Core Bus Corridor 11: Tallaght to Terenure

17th April 2020

Appendix A: Templeogue Bridge to Springfield Avenue

Appendix C - Terenure Place alternative design

Inbound motor traffic [purple], inevitable destination junctions if driving through Templeogue Village [purple circles], bus gate [C], destination affected by bus gate is Terenure Village [D]. Alternative routes to purple circles and Terenure Village shown in blue.

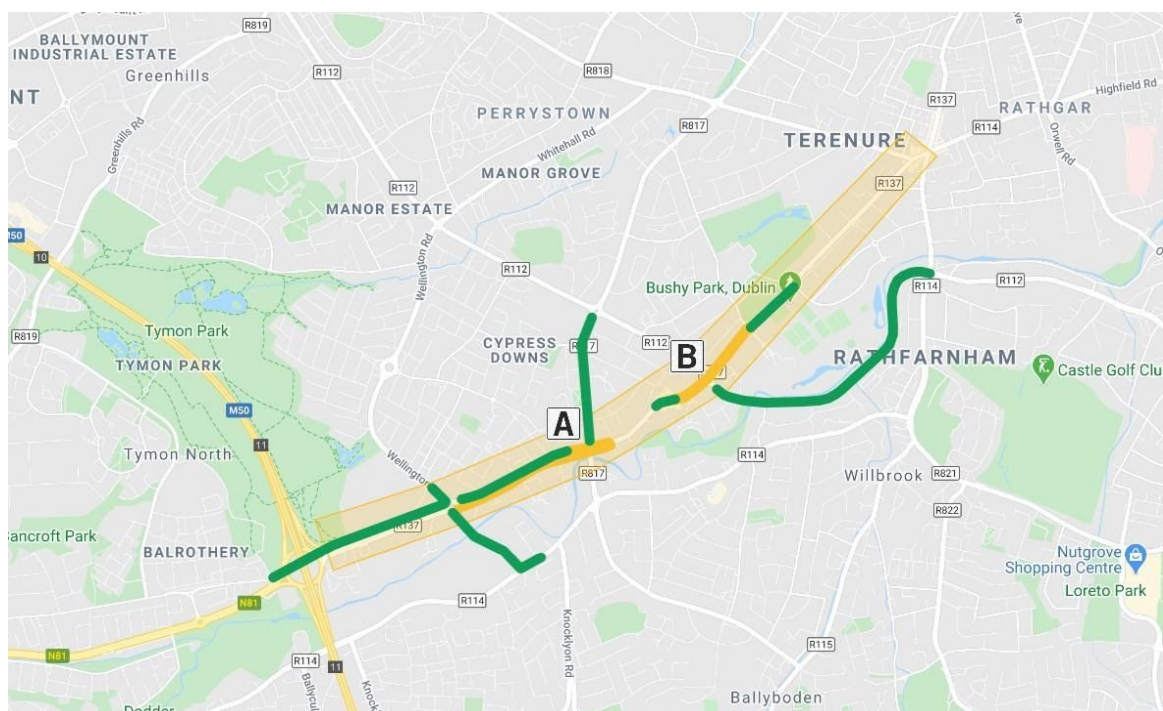
Looking at the route as a whole, Templeogue Road will be closed to inbound motor traffic before Terenure Village, which should result in less vehicles using this A-B link road. Inbound through motor traffic using the CBC route will inevitably end up at one of the junctions marked with the purple circles on the map below. Alternative connecting routes are highlighted in blue and demonstrate the various options available to drive to the purple nodes. Some blue lines are rat-runs but not all rat-runs are shown.

While the point is to show that some drivers will inevitably take other routes, it also highlights an important issue for cyclists locally (refer to the cycling infrastructure map below). There will be increased motor traffic on other routes with poor cycling provision (note two recent cyclist fatalities are marked in red signs below).

Inbound Motor Traffic Management - Junction A

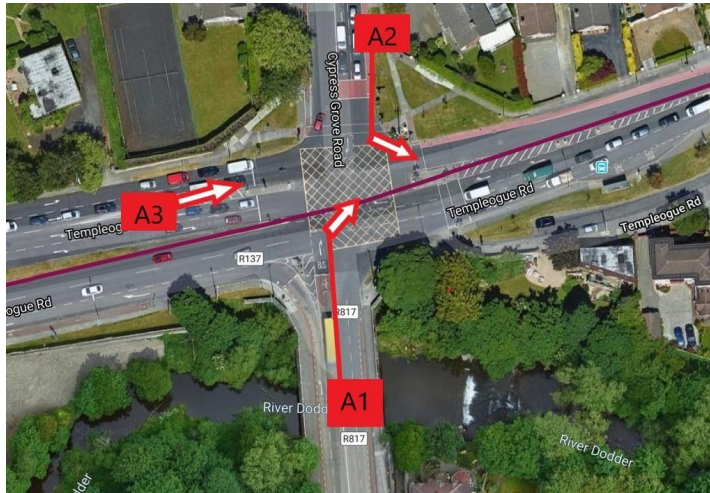
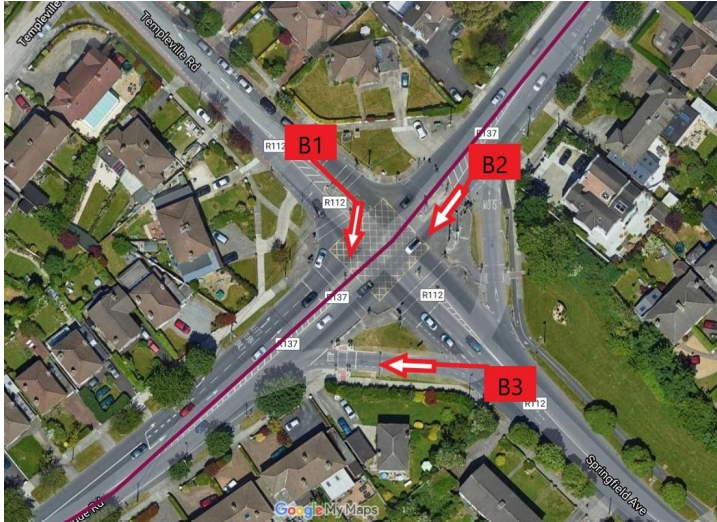
Consider motor traffic inbound at Junction A.

- Traffic A1: no right turn except buses (existing arrangement)
- Traffic A2: very limited traffic input (NB potential "rat run" through Cypress Downs may need to be cut off)
- Traffic A3: vast majority of through traffic input to the junction

A3 traffic inbound needs to be throttled back at Junction A. Rather than stacking congestion along the 350m to the Village, vehicles would be stacked westward on the dual carriageway from Junction A toward the Spawell Roundabout. For example:

- Junction A to Spawell 0.75km x2 lanes = 1.5km of motor congestion space
- Junction A to M50 1.35km x2 lanes = 2.7km of motor congestion space

As there would be no congestion on approach to the Village, the Part I bus lane would then be redundant and could be repurposed as a cycle track to complete the inbound cycle route. The traffic lights at Junction A should only let in enough motor vehicles that can clear Junction B. This will allow the bus to access Junction B unobstructed. The NTA proposed bus gate located west of Templeogue Tennis Club would have to perform a similar function anyway.

Junction B

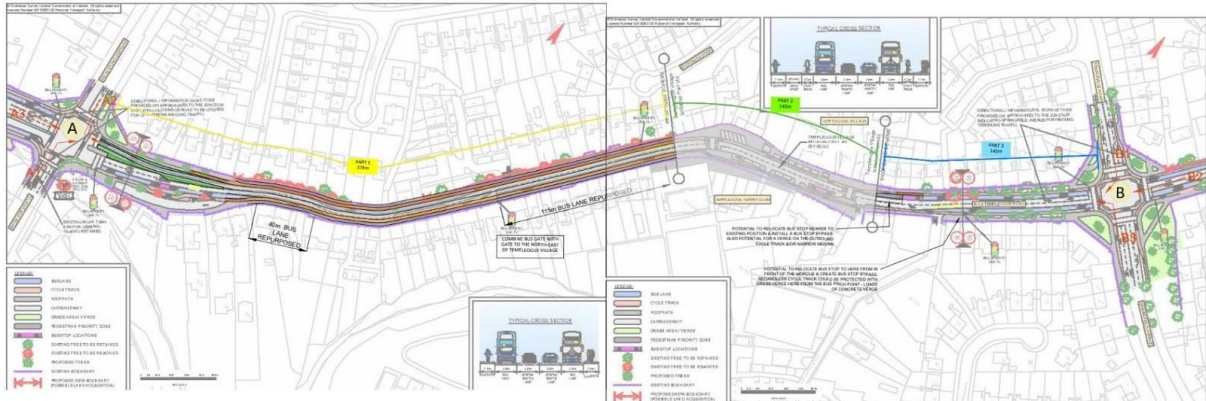
At Junction B outbound, 3 different bus gates are proposed with short spacing in between. They could benefit from rationalisation.

Considering a B-A link, input traffic at B could be controlled to limit congestion along the link road thereby allowing space to be allocated to cycling infrastructure.

- B1 very limited volume and tends to be local traffic.
- B2 and B3 both feed the vast majority of through traffic into the Village.
- B2 motor congestion can be stacked back toward Terenure Village. There is 1.1km of general lane back to the start of the bus lane near Terenure.

- For B3, on Springfield Avenue there is at least a 250m corridor from the rear of Tesco up to the junction to allow for a designated left turn lane if required. There is then a further 1.3km general lane along the Dodder to Rathfarnham.

- The proposed bus gate at Hollingsworth could potentially be retained.
- The bus gate just west of the Tennis Club would be removed and the 150m of bus lane/congestion lane repurposed to extend the cycle tracks west of the village.

- Nearer to Templeogue Bridge at the narrow point, the bus lane start would be moved slightly to the west by 43m, thus allowing the outbound cycle route to be completed and continuous.
